Subject: Response to Portion of NRC Request for Additional Information Letter No. 215, Related to ESBWR Design Certification Application - Auxiliary Systems - RAI Number 9.4-53

**Response to Portion of NRC Request for
Additional Information Letter No. 215
Related to ESBWR Design Certification Application
Auxiliary Systems
RAI Number 9.4-53**

NRC RAI 9.4-53

Operation of the CONAVS post 72 hours

Figure 2.16.2-2. CONAVS Functional Arrangement Diagram

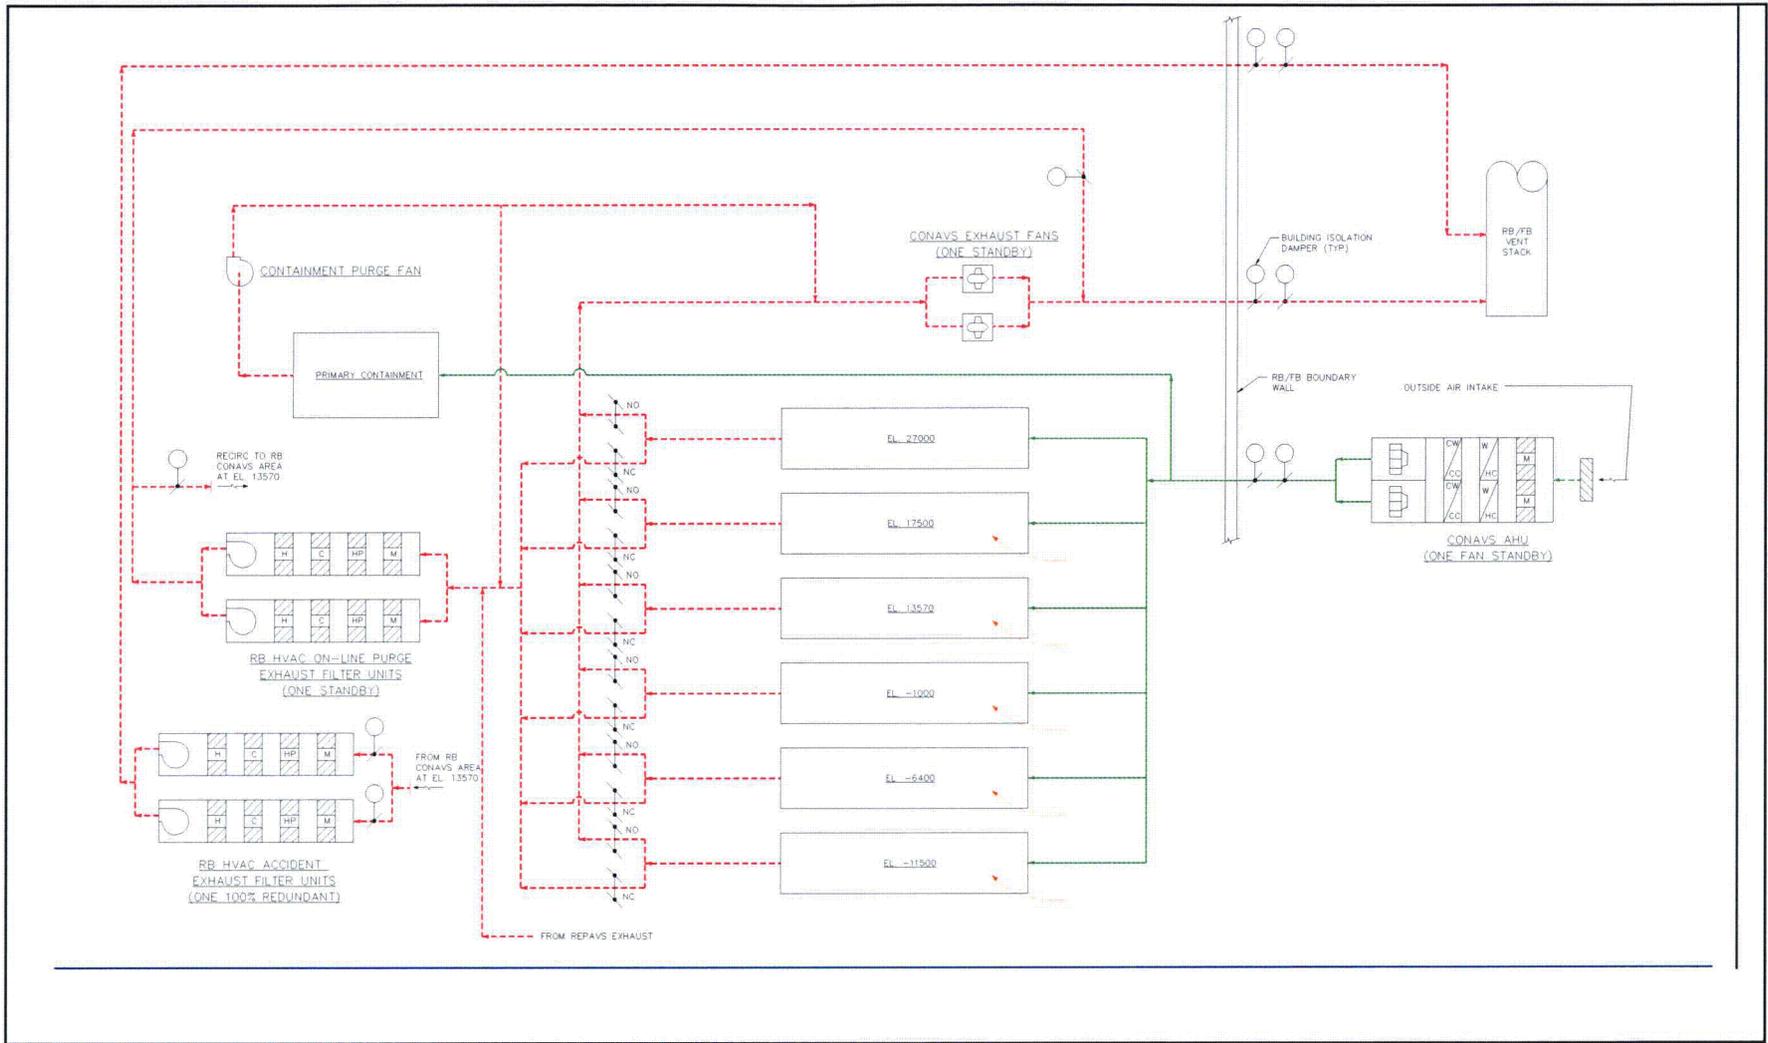
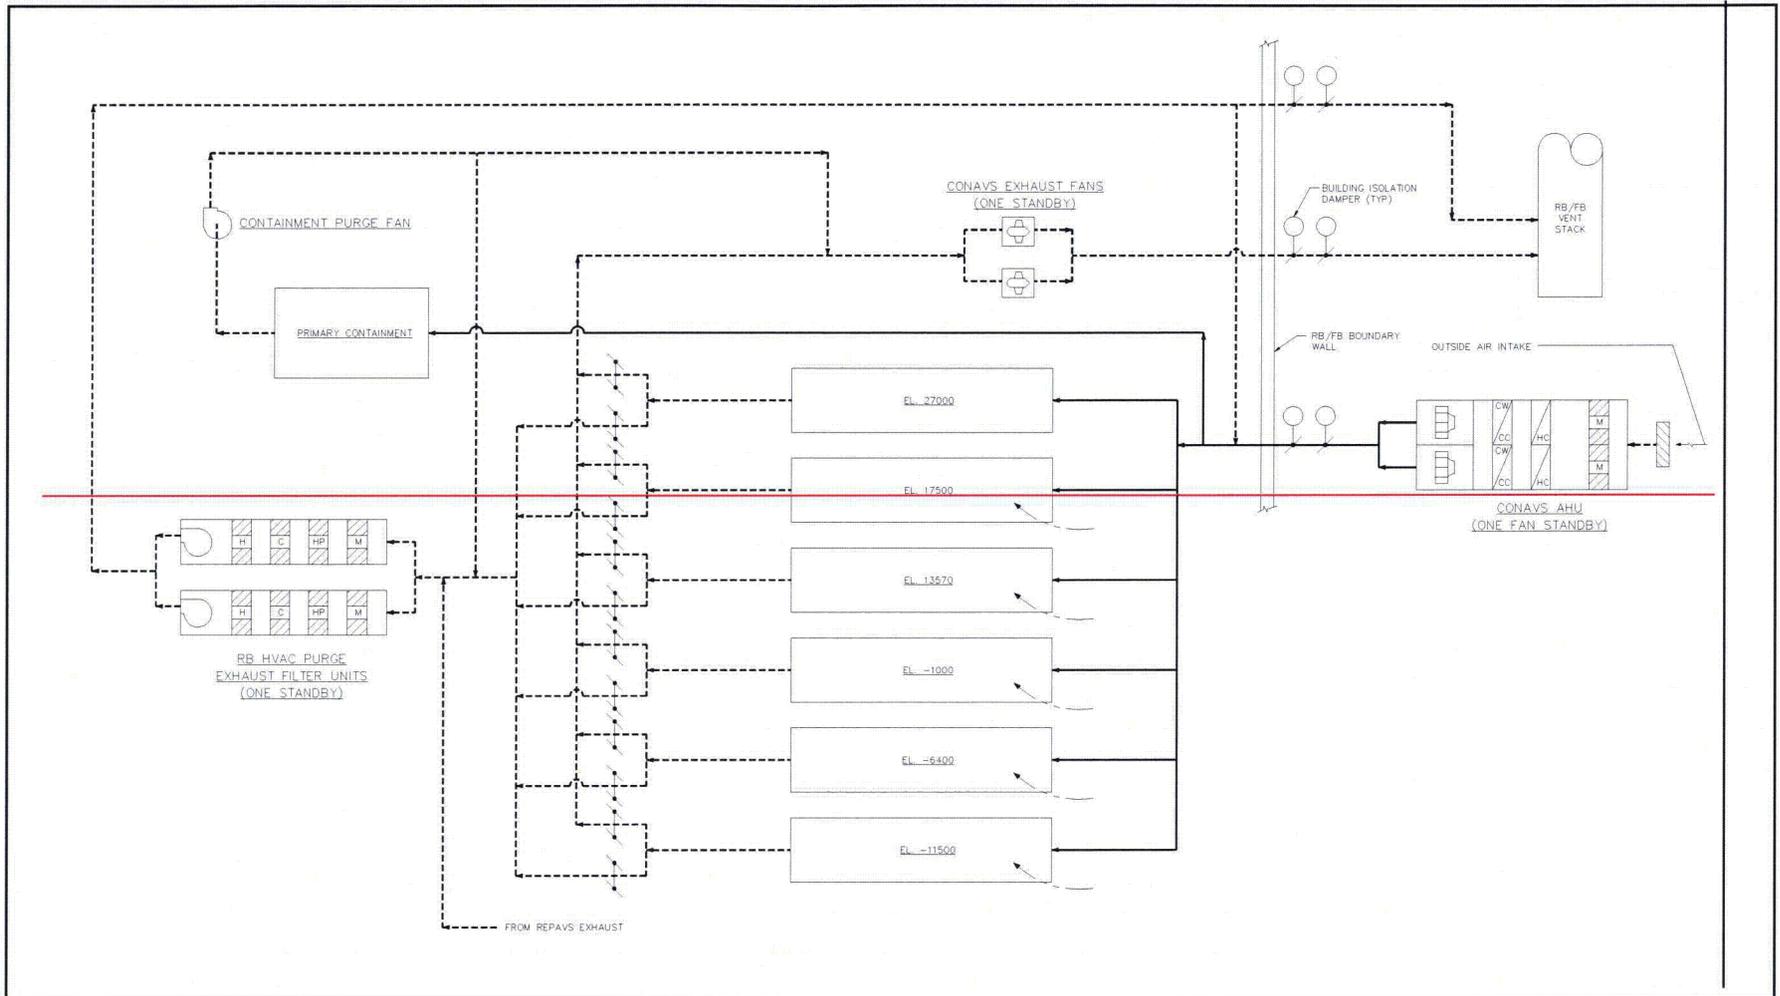
In Item B of the GEH response to RAI 14.3-221, statements are made about the operation of the CONAVS post 72 hours to clean up the contamination in the contaminated area of the building and release it through filters to the stack which is monitored. This is an unanalyzed condition since the release path through the non-safety related CONAVS and filters to the stack have not been considered in the design basis analysis. The impact would be a clean up of the reactor building contaminated area but may increase dose to the CR operators to the point at which it exceeds the GDC 19 Control Room Habitability limit.

DCD Tier 1, subsection 2.16.2.1, Table 2.16.2-2, and Figure 2.16.2-2 are being updated under Revision 6 to include the write-up, tests, and figure addressing the addition of the Reactor Building HVAC Accident Exhaust Filter Units.
